**Project # PR-2018-001482**  
SI-2023-01925 - Site Plan - EPC

Tierra West, LLC, agent Riverside West, LLC, requests a new Site Plan-EPC, for all or a portion of Tract 1 of Summary Plat Land Division of West Land Development Co., included together with A Tract of land within these 1/4 SE, 1/4 SEC, 34 T10N, and R2E and a Tract of land east of Amole Del Norte Diversion Channel North of Section line of section 34 & 3, located at 2911 Ervien Ln. SW, north west of the intersection of Ervien Ln and Coors Blvd., approximately 42 acres. (M-10-Z)  
Staff Planner: William Steele

RE: PR- PR-2018-001482, SI-2023-01925–Site Plan-EPC \_ Riverside Mobile Home Park

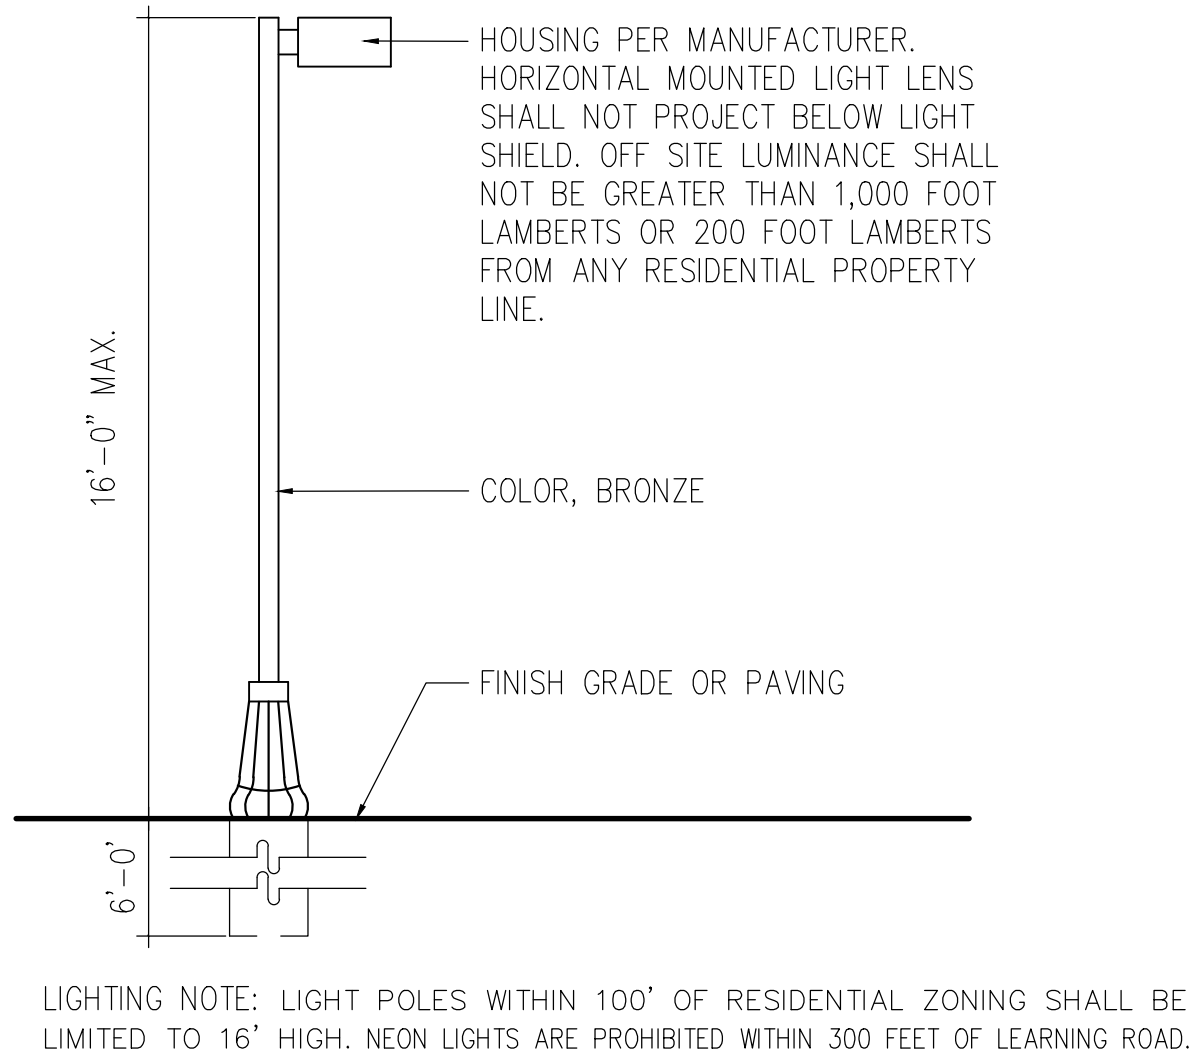
3. **Comment:** Condition 3a has been partially satisfied. Note number 3 has not been changed to reflect the light pole maximum of 16' as shown on Detail Sheet C5.0. Keyed Note number 7 has been changed to reflect this condition.

**Response:** Confirmed.
6. **Comment:** Condition 6 has been partially met and replaced with a standard 16' max light pole detail on sheet C5.0. The note, "within 100' of Residential" was not added to the max light pole detail.

**Response:** All notes referring to lighting has been updated to reflect a maximum height of 16'
4. **Comment:** Condition 3b has been partially met. The site plan has not specified LANDFILL GAS BUFFER AREAS on the drawing or in the legend in parenthesis next the LANDFILL LIMIT.

**Response:** All notes referring to light has been updated to reflect "within 100' of Residential."
7. **Comment:** Condition 7 has been met and a solid waste site plan has been approved on 5/13/24. Please submit a copy of the approved drawing for verification.

SHEET #  
C5.1

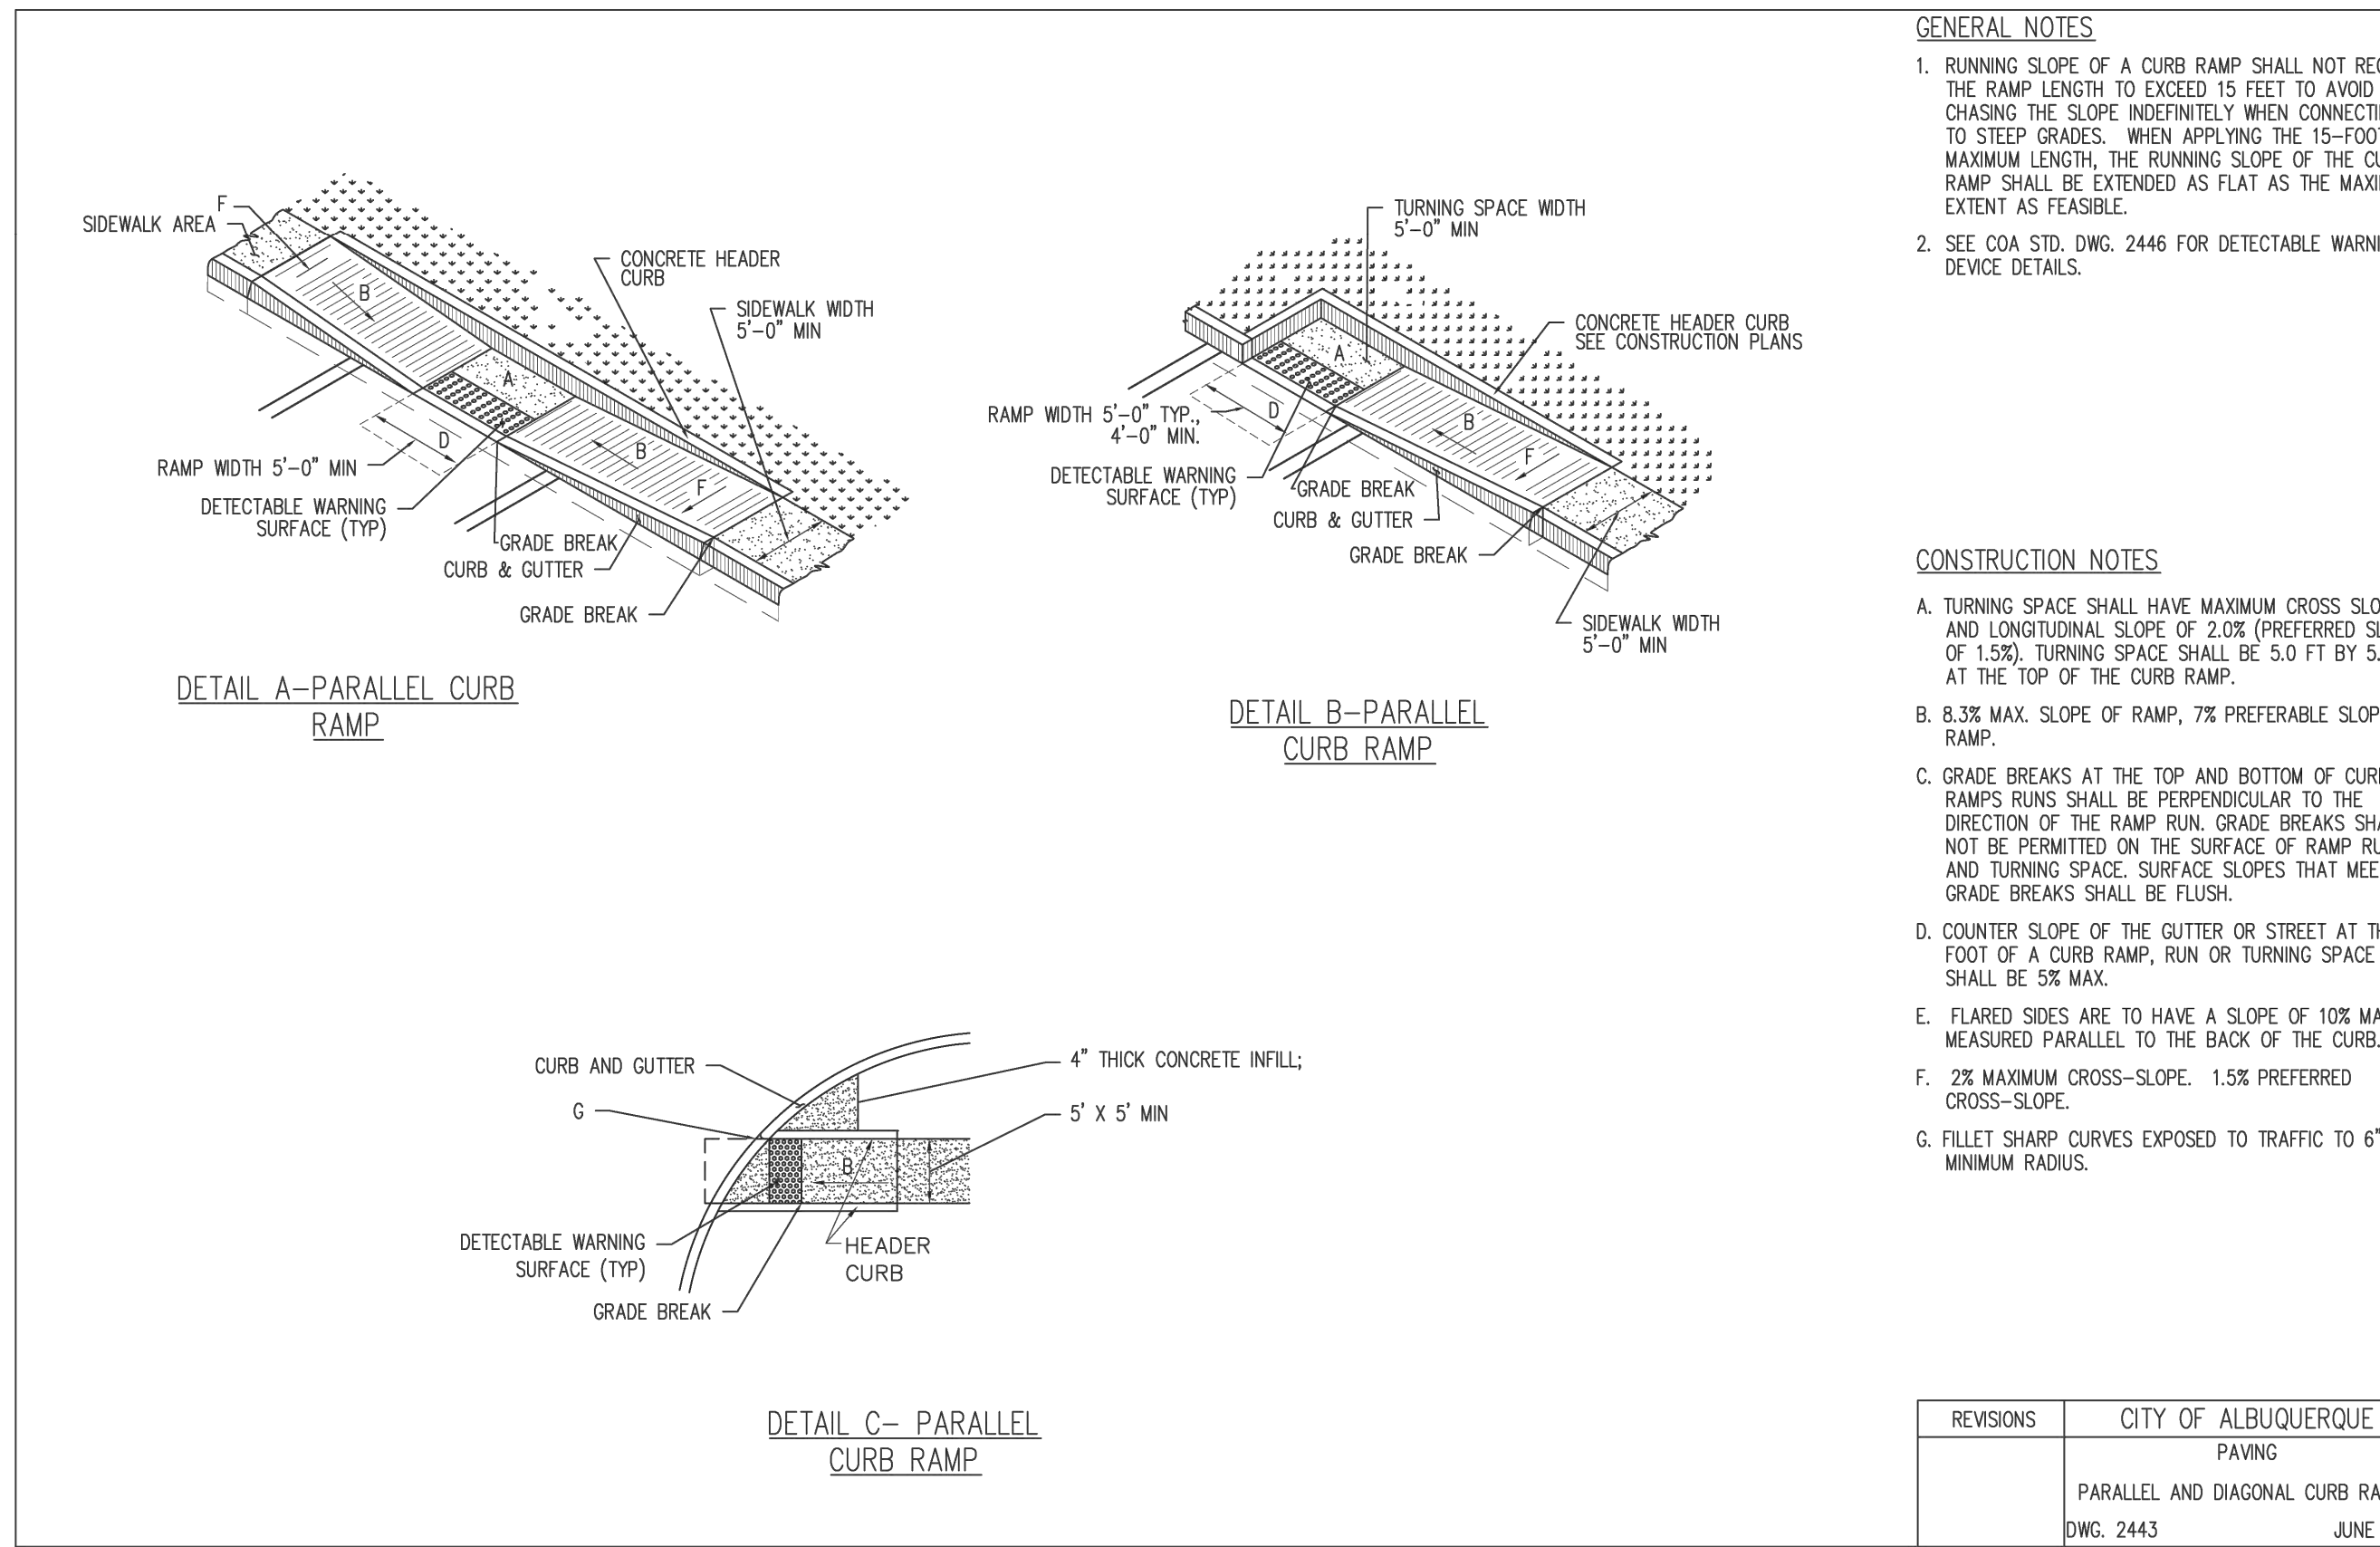
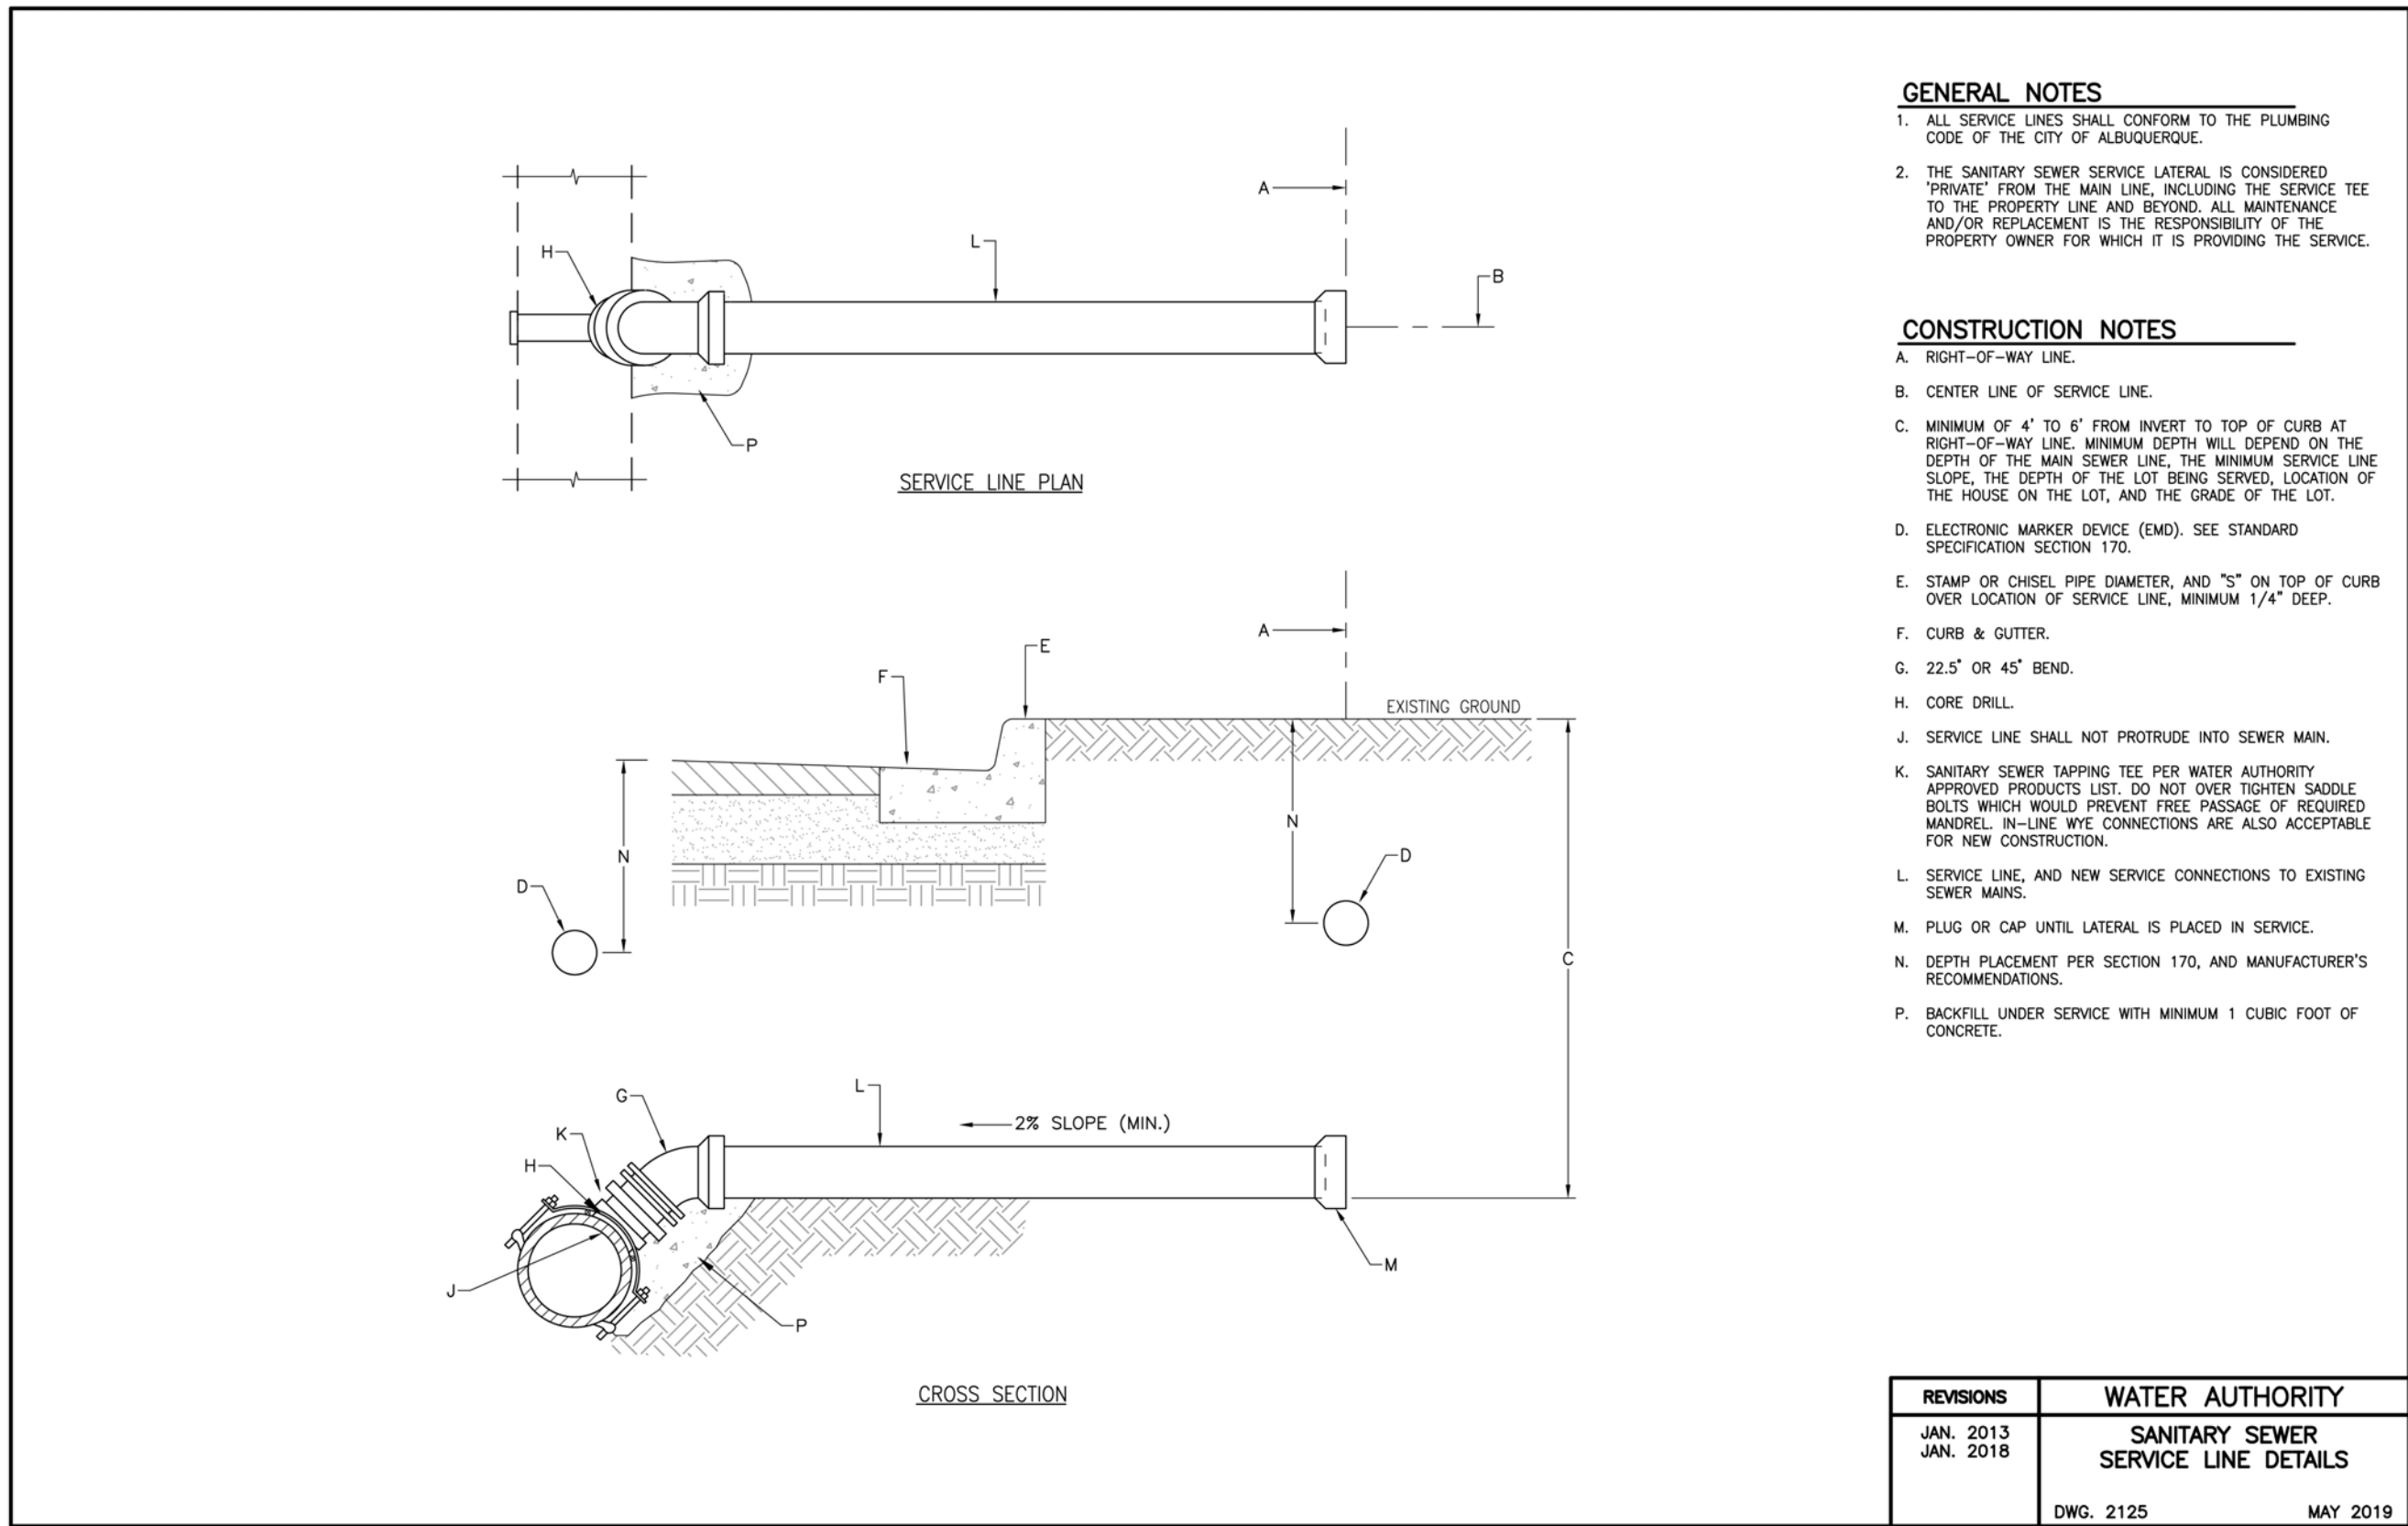
**Response:** Sheets were added back into the plan set.
2. **Comment:** Detail Sheet C5.1, detail for Parallel and Diagonal Curb Ramps was removed. Please reinstate

**Response:** Detail was reinstated.
3. **Comment:** The Landscape Sheet numbering has been changed from L1.0 to LS-101 and no longer matches the Index to Drawings on the Site Development Plan Sheet. Please revise.
